ADDENDUM NO: 1

PROJECT: **SITE IMPROVEMENTS AT FRANKLIN CENTRAL JUNIOR HIGH**

CONTEXT PROJECT NO: 22-1613 DATE: 2/13/2024 BY: Fred Prazeau

Sheet No:
C421

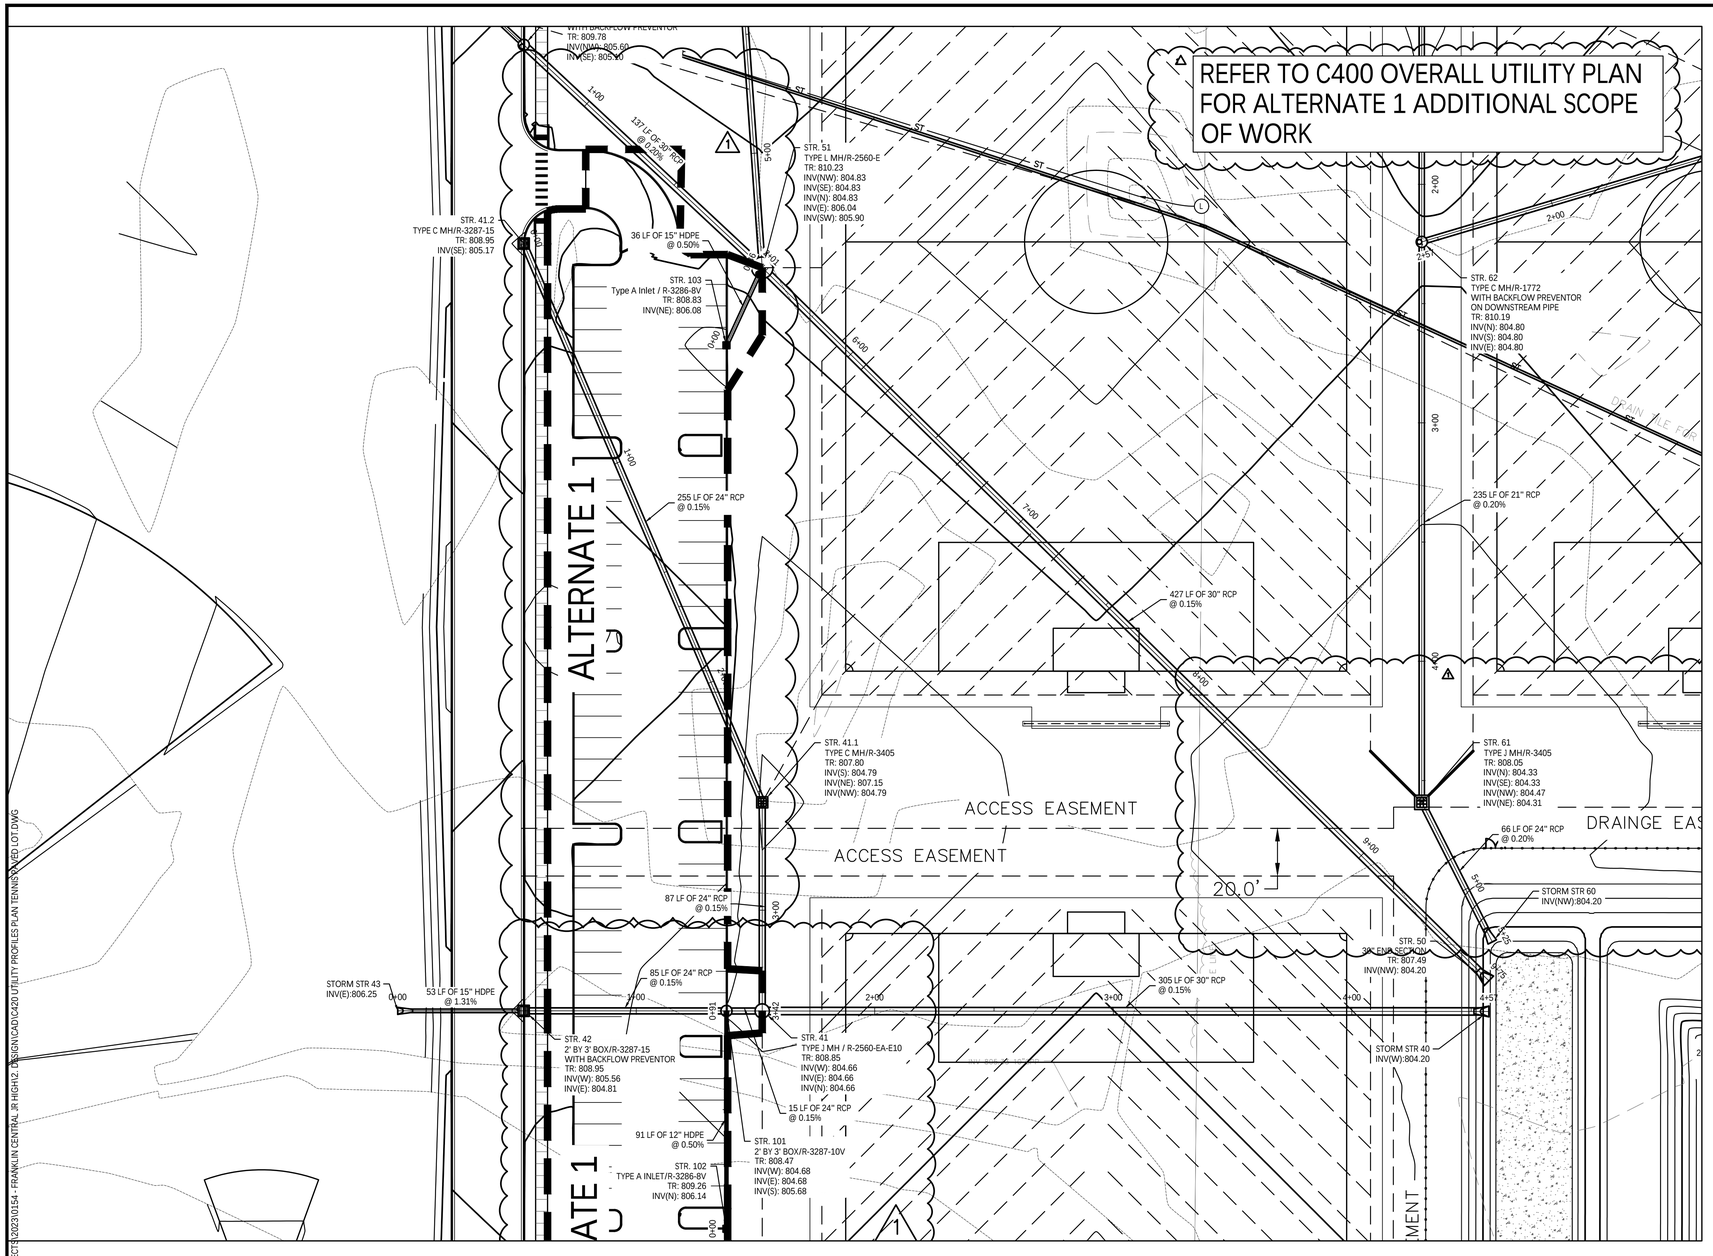
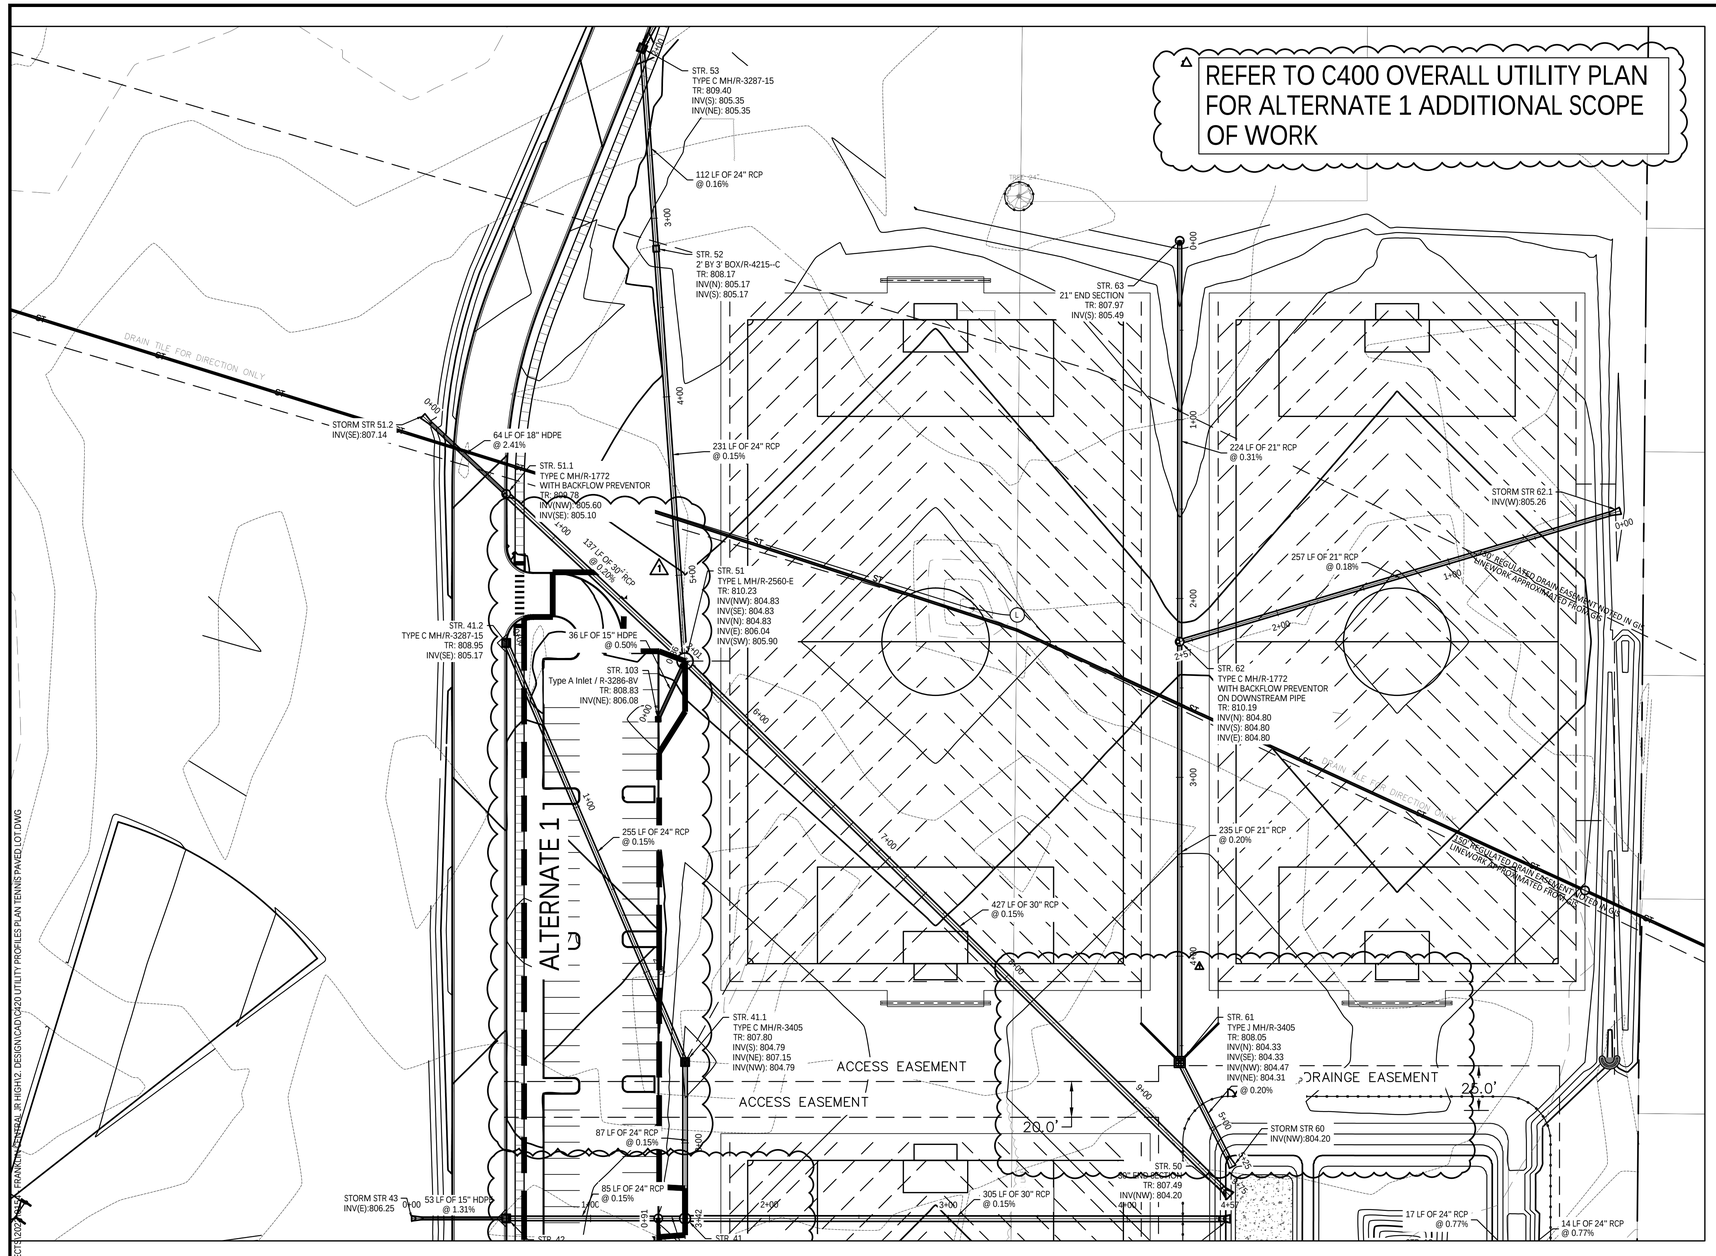
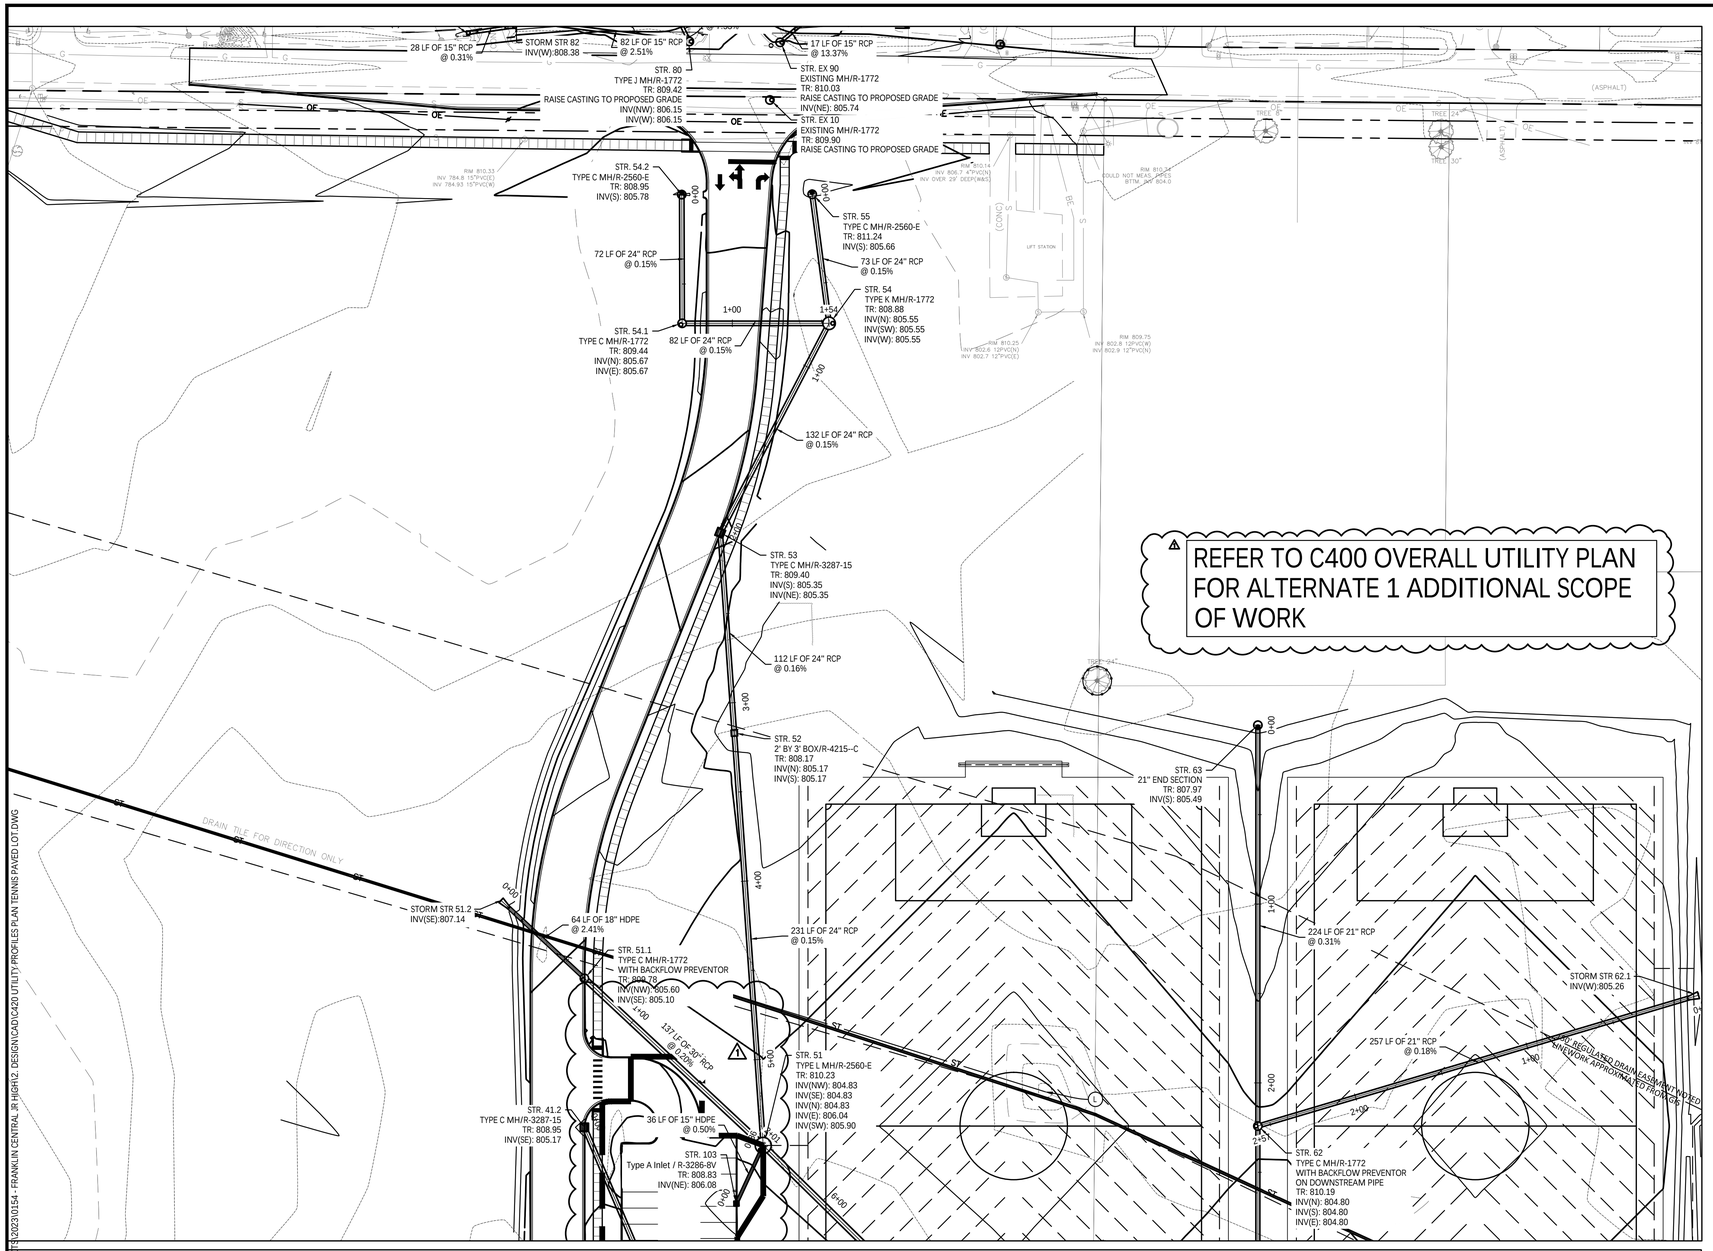
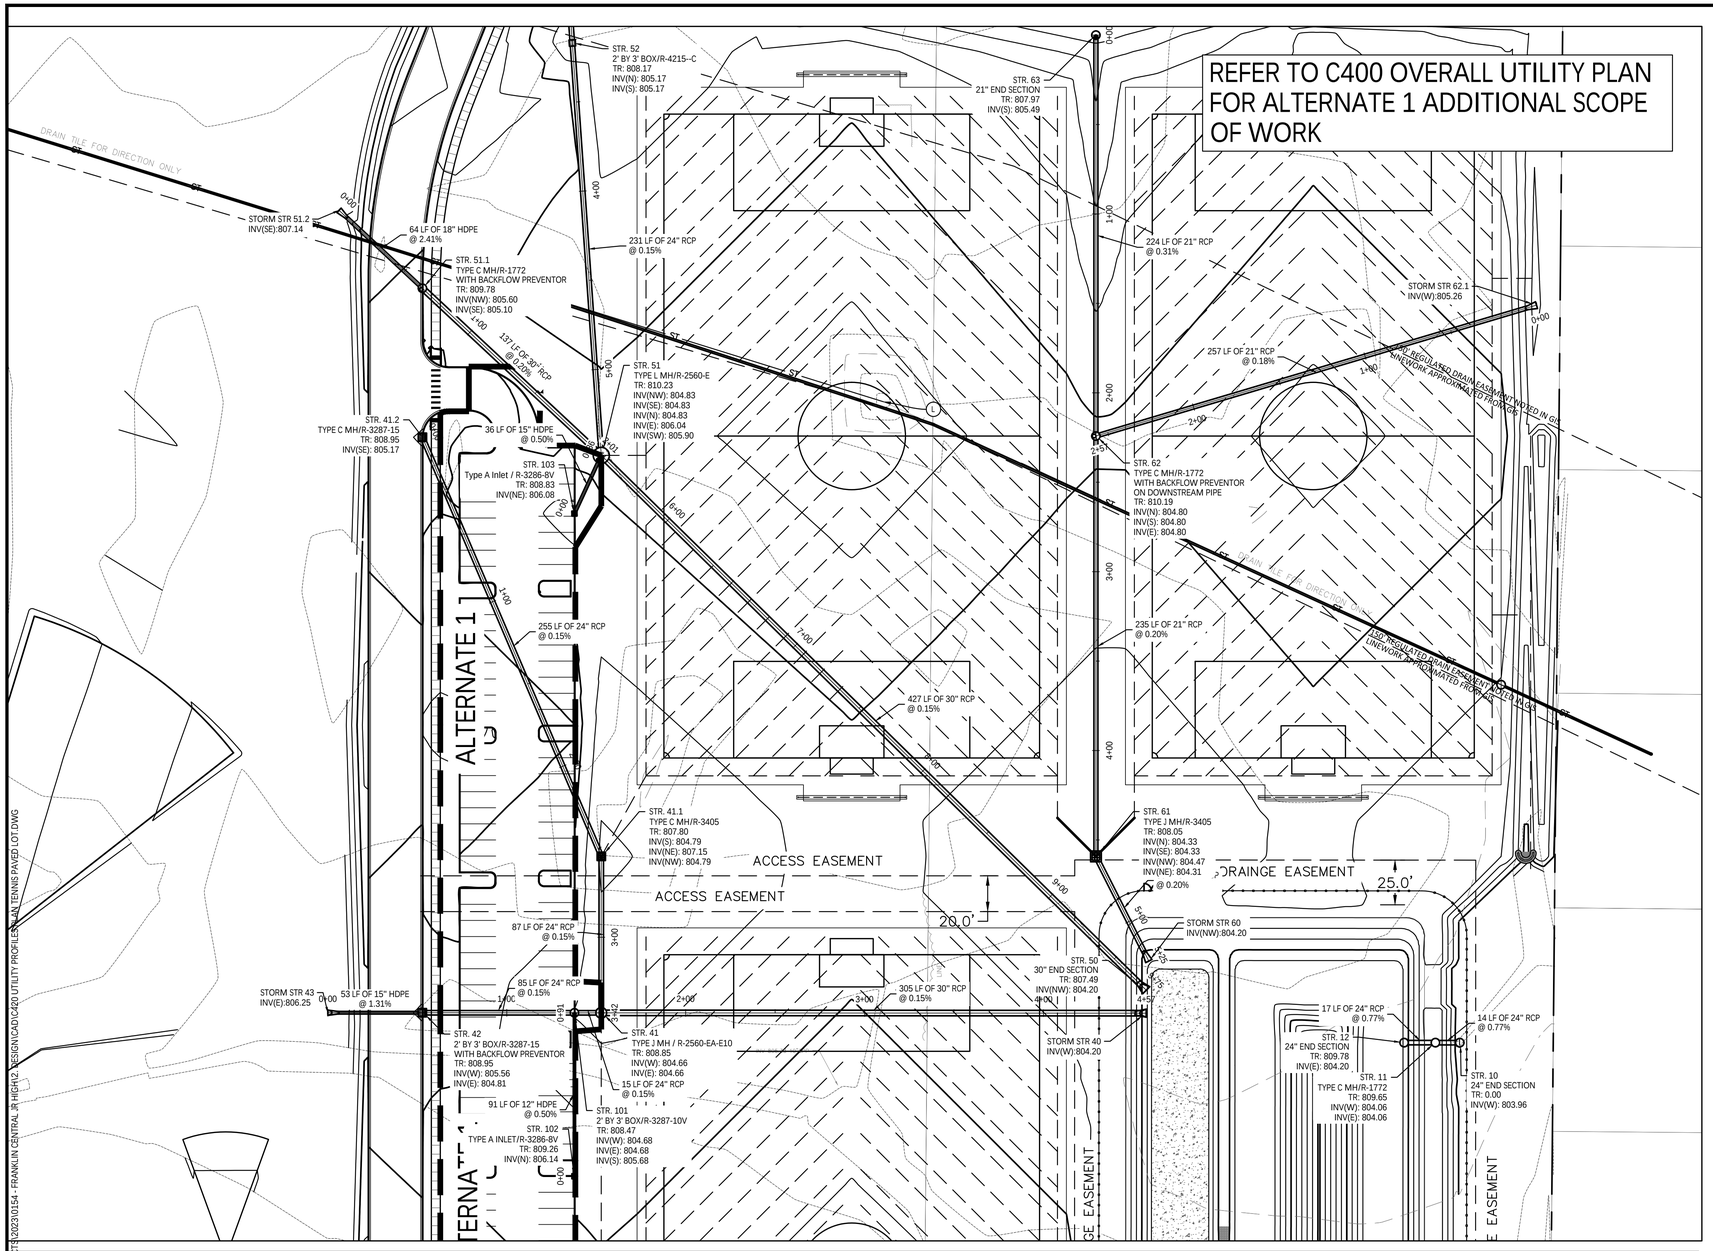
4. C420-Series Utility Profile Plans reissued to address City comments, including clarification to storm structures to reflect grading revisions and sufficient cover, subsurface drainage as indicated on plans, and storm structure network for Alternate #1 – Soccer Parking. [Note that Sheets C426 & C427 are newly-added]
